ADDENDUM 1

PROJECT NAME: APACHE CREEK LINEAR PARK LIGHTING UPGRADES

DATE: September 11, 2020

PROJECT NO: 29652000

SHEET:
ES1.3

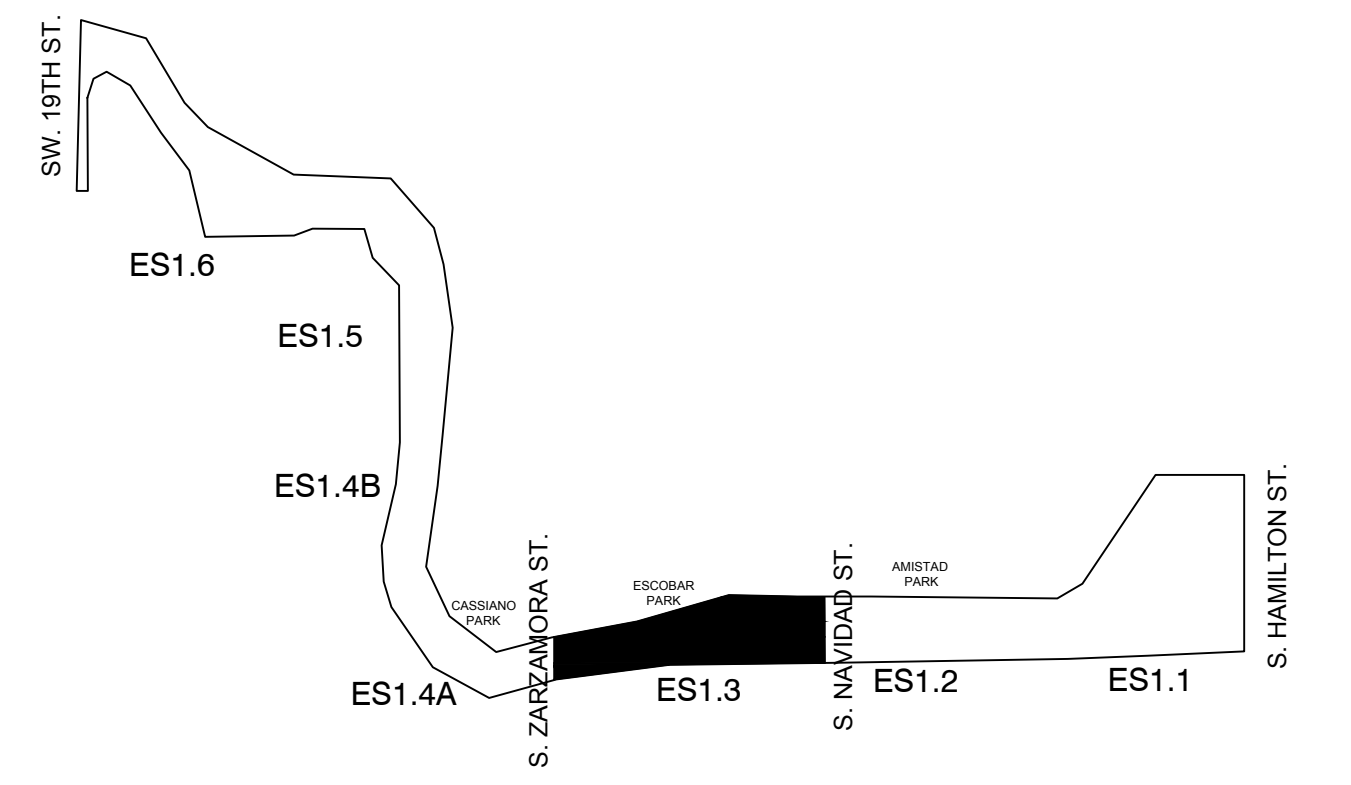
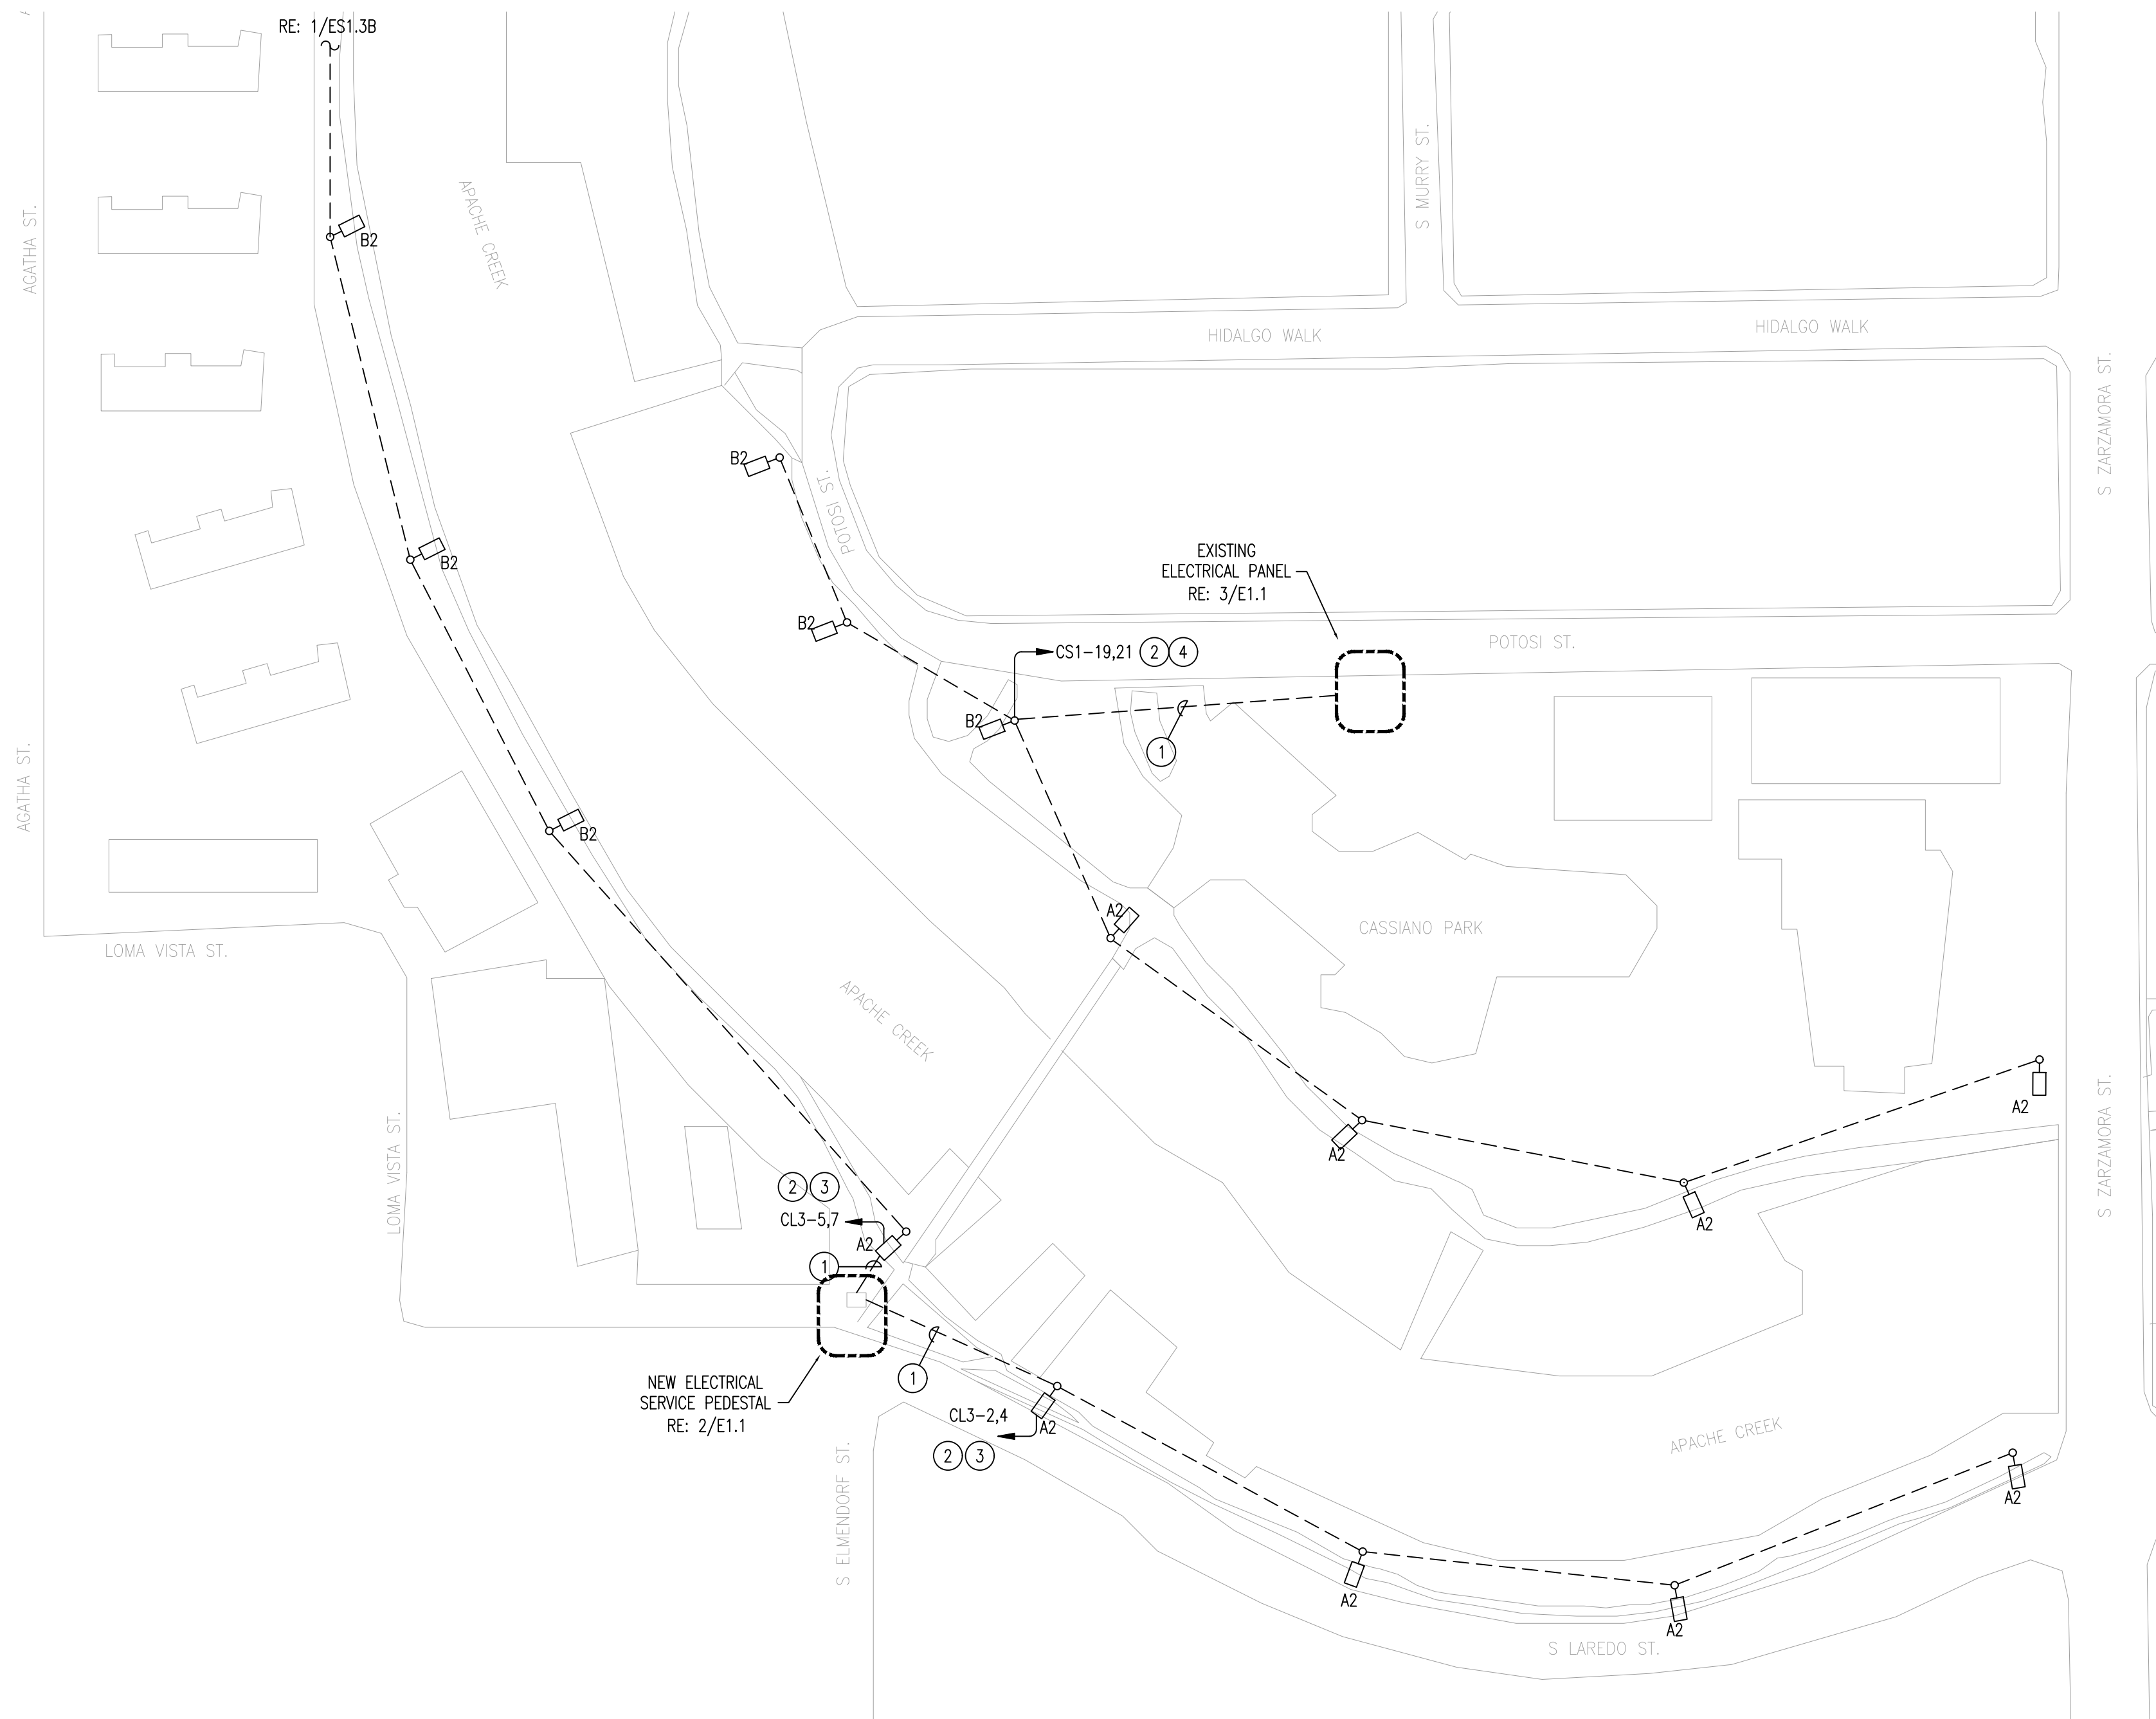
- x. RE: Plan Sheet ES1.3:
 - a. Item 1: Revised key note 5.
 - b. Item 2: Revised fixture type, as indicated.
 - c. Item 3: Added note to contractor regarding pole base location, as indicated.

2. Fixture types A and B appear on sheets ES1.2 and ES1.3 but not on light fixture schedule. Can you please clarify?
 - Answer: See addendum 01 for updated drawings.

1. PROVIDE CONDUIT(S) FOR CIRCUITRY, AS INDICATED. COORDINATE ROUTING WITH ENGINEER(S) PRIOR TO TRENCHING TO AVOID CONFLICTS WITH ANY FIELD ITEMS.
2. PROVIDE (1) 1" CONDUIT FOR LIGHTING CIRCUIT WITH (2)#8 AWG CU, AND (1)#8 GND.
3. ROUTE CIRCUIT THRU LIGHTING CONTACTOR/TIMECLOCK ASSEMBLY.
4. PROVIDE IN-GROUND PULL BOX. COORDINATE LOCATION WITH ENGINEER(S) PRIOR TO ROUGH-IN TO AVOID ANY CONFLICTS WITH ANY FIELD ITEMS.
5. PROVIDE NEW (1) 1" CONDUIT ACROSS BRIDGE. ROUTE CONDUIT UNDERNEATH AND ACROSS BRIDGE.

SHEET:
ES1.4A

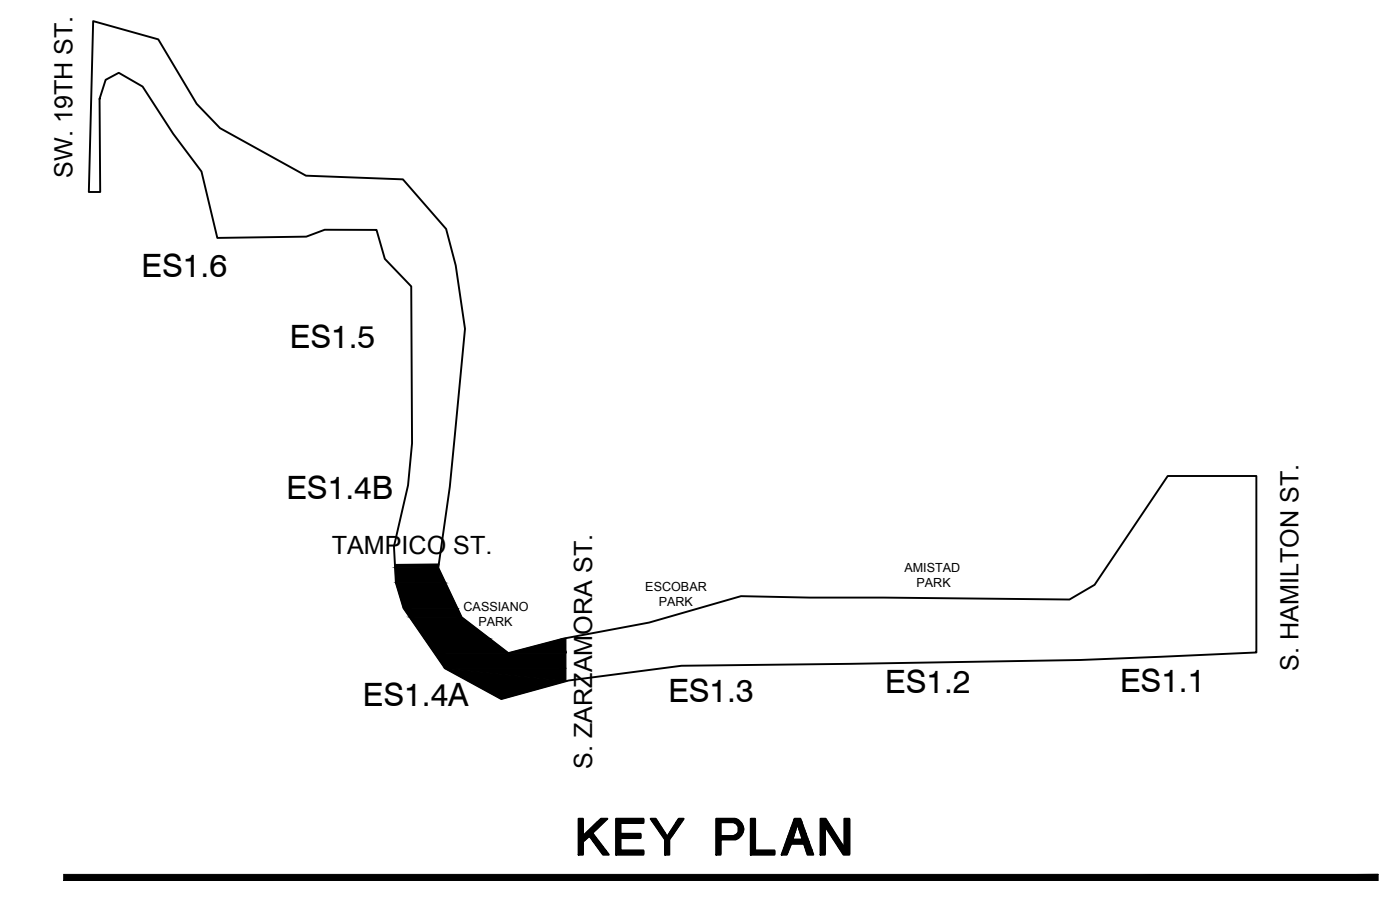
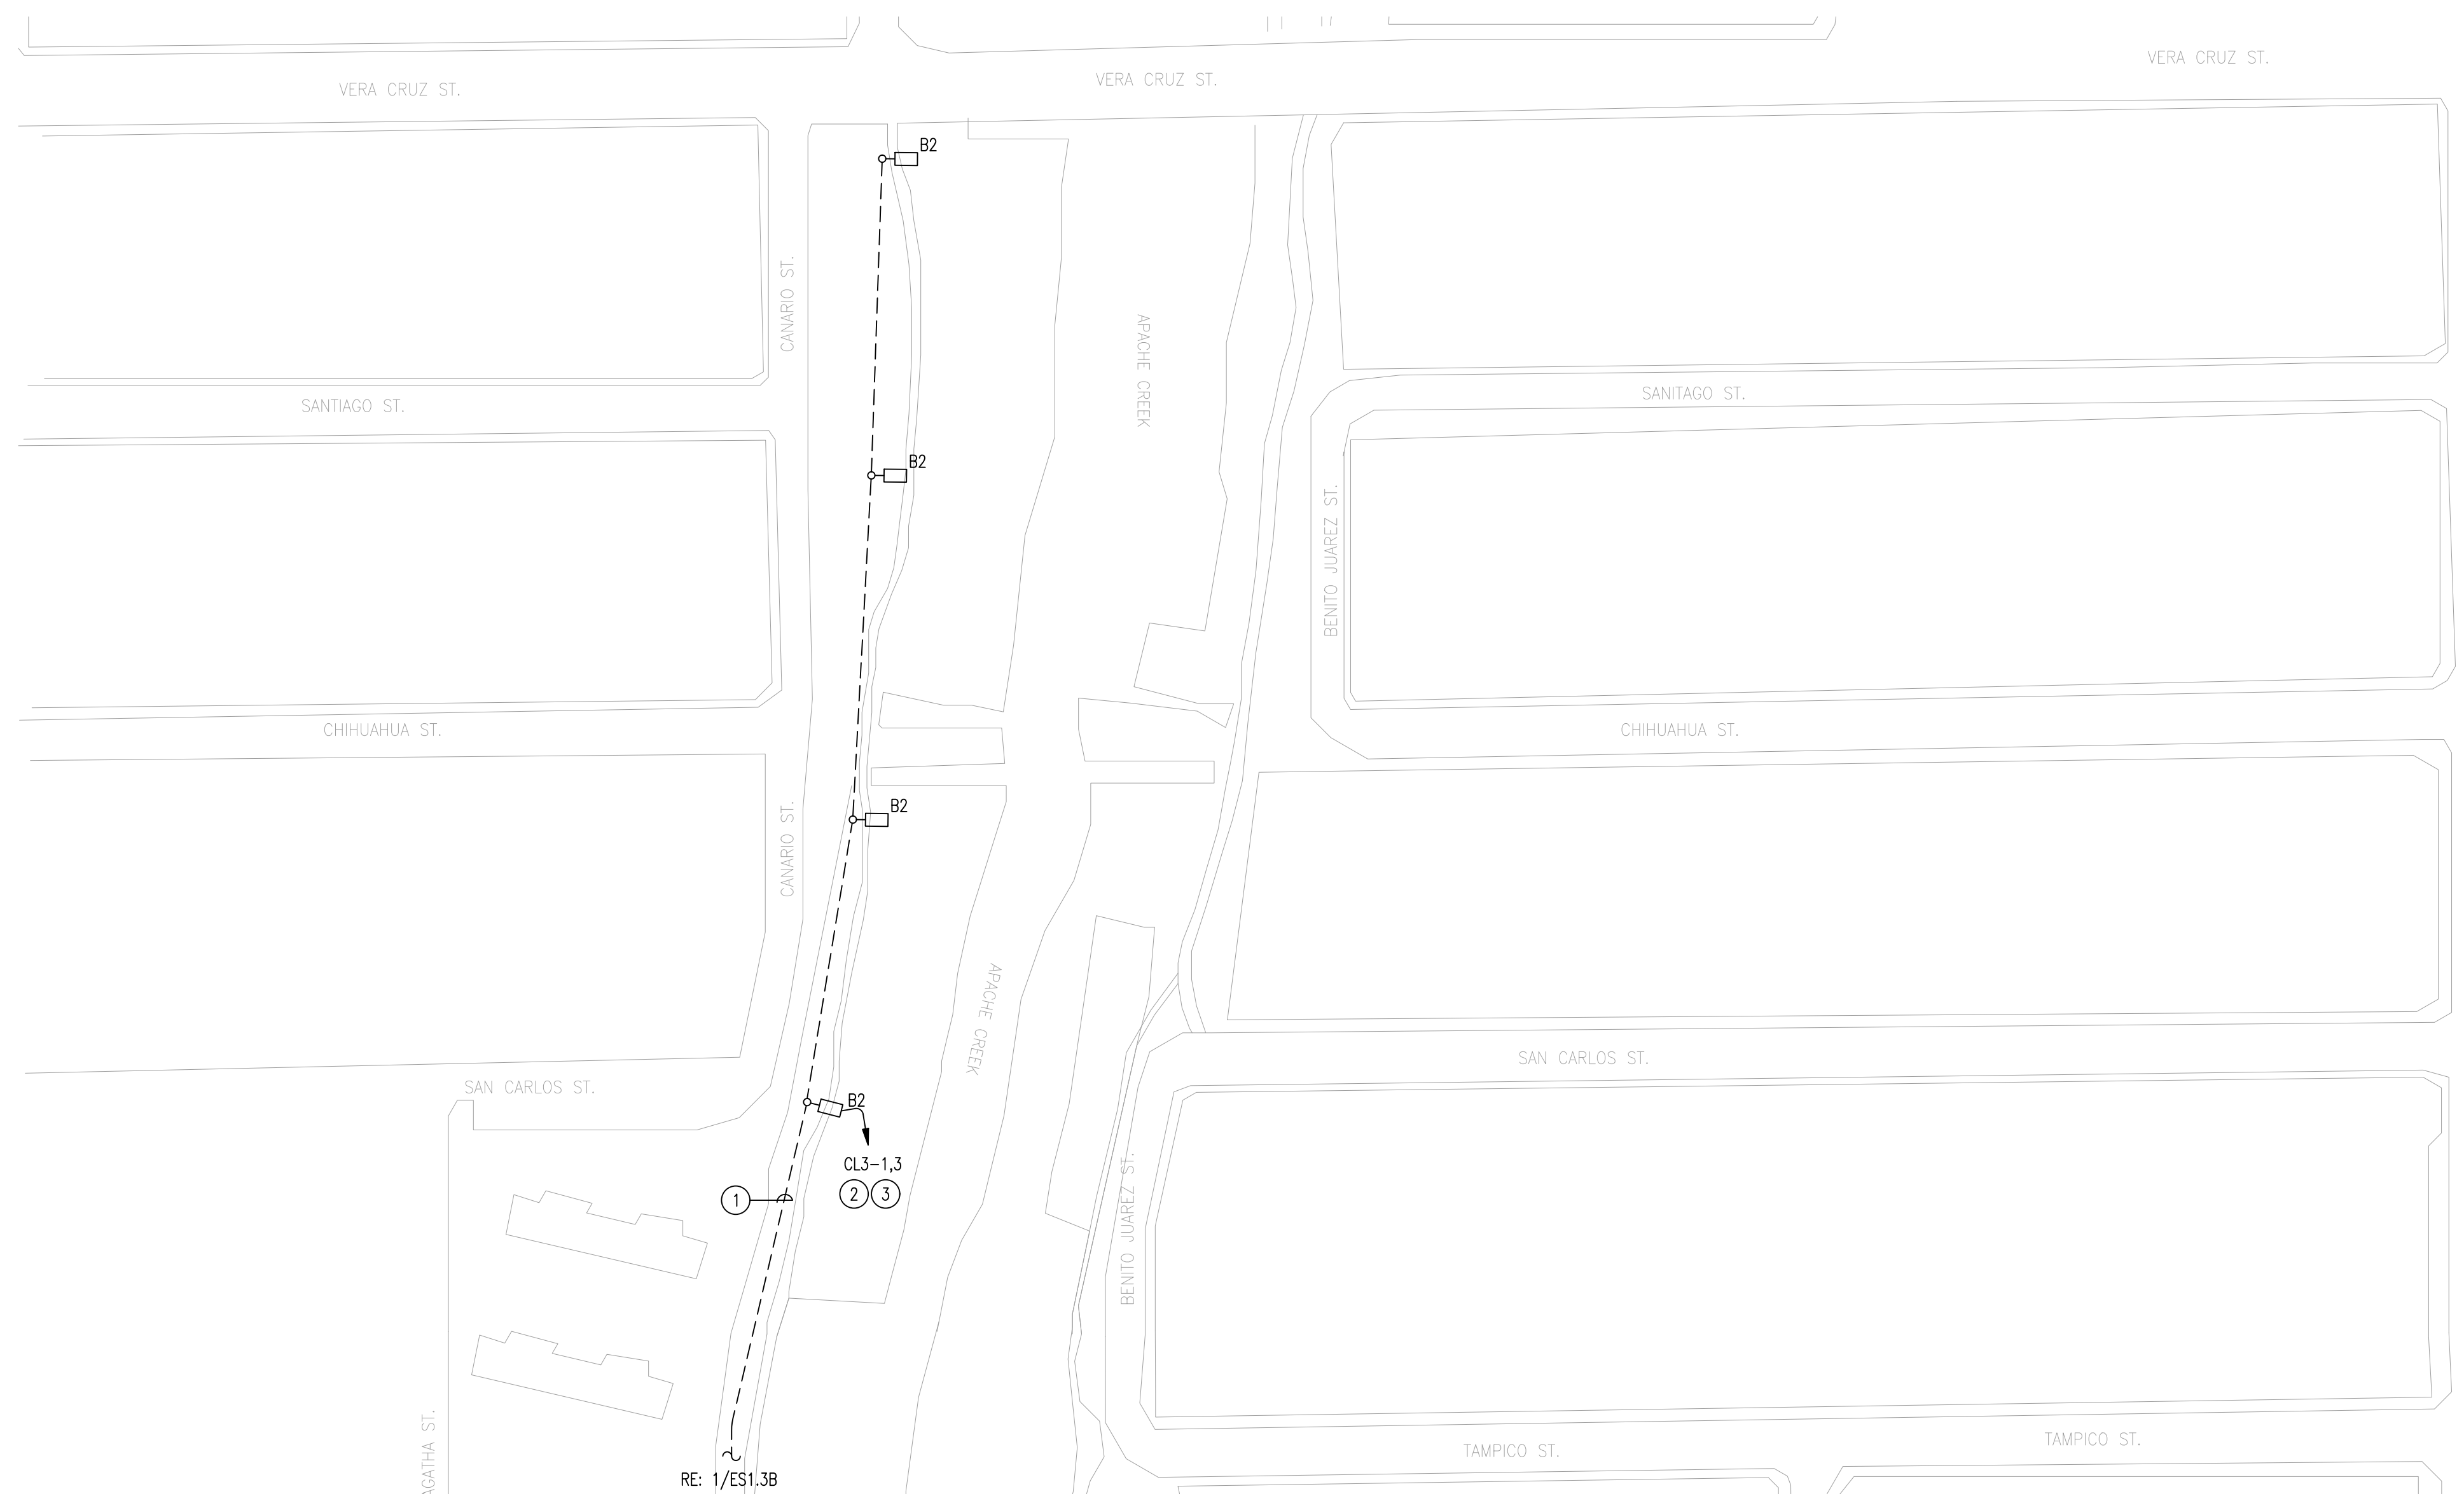
- xi. RE: Plan Sheet ES1.4A:
 - a. Item 1: Added note to contractor regarding pole base location, as indicated.
- xii. RE: Plan Sheet ES1.4B:
 - a. Item 1: Added note to contractor regarding pole base location, as indicated.

1. PROVIDE CONDUIT(S) FOR CIRCUITRY, AS INDICATED. COORDINATE ROUTING WITH ENGINEER(S) PRIOR TO TRENCHING TO AVOID CONFLICTS WITH ANY FIELD ITEMS.
2. PROVIDE (1) 1" CONDUIT FOR LIGHTING CIRCUIT WITH (2)#8 AWG CU, AND (1)#8 GND.
3. ROUTE CIRCUIT THRU LIGHTING CONTACTOR/TIMELOCK ASSEMBLY.
4. ROUTE CIRCUIT THRU EXISTING LIGHTING CONTACTOR.
